**Application for Variation of an Environmental Permit**

Project Title  
**First Stage of Desalination Plant at Tseung Kwan O - Investigation, Design and Construction**

Figure Title  
**Revised Figure 1 - Project Location Plan**

First Stage of Desalination Plant at Tseung Kwan O  
– Investigation, Design, Construction

### Annex 4 – Deviation of Fresh Water Main Alignment No. 4

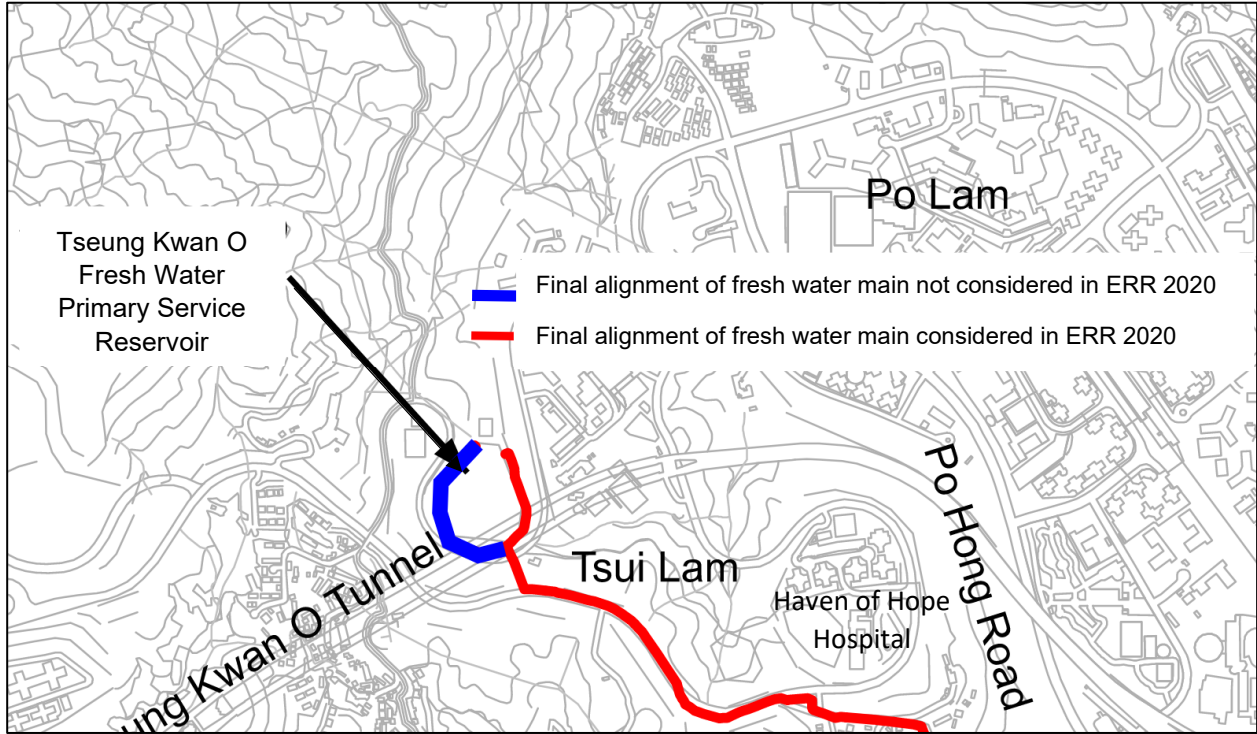
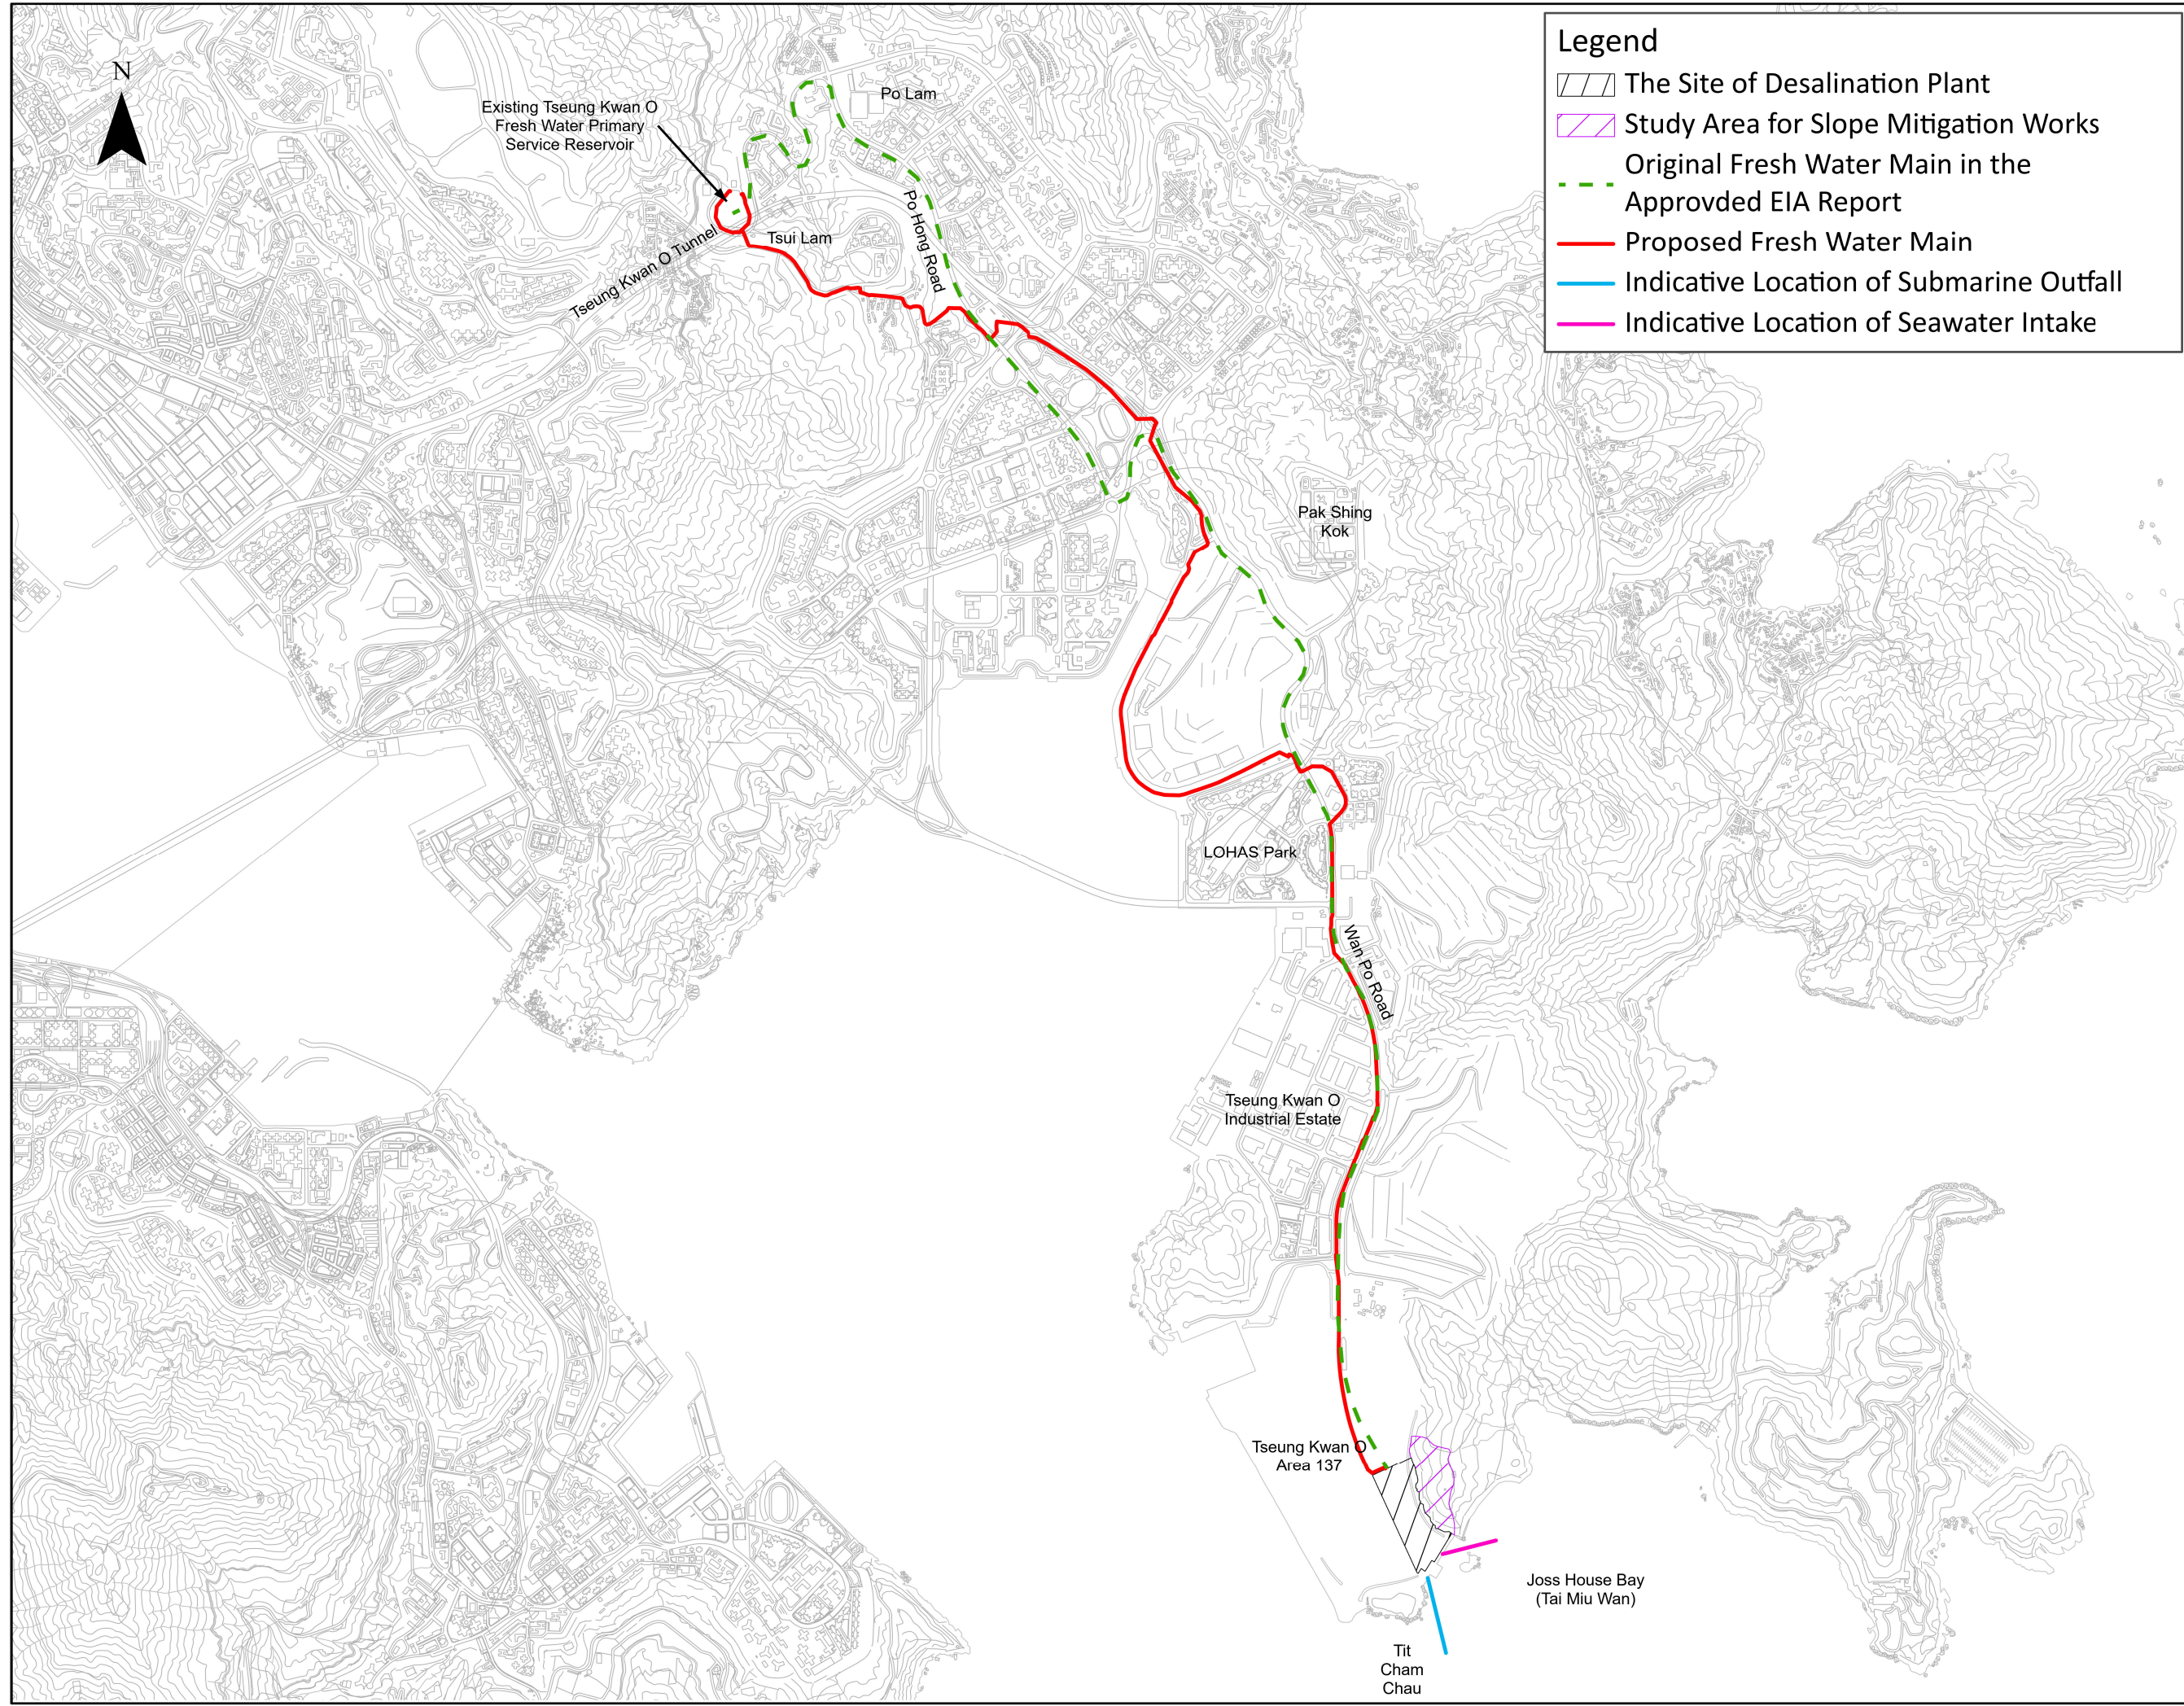
The final alignment of the fresh water main runs along the footpath on both sides of the Tseung Kwan O Fresh Water Primary Service Reservoir, which was not considered in the ERR 2020 as illustrated in the figure below.
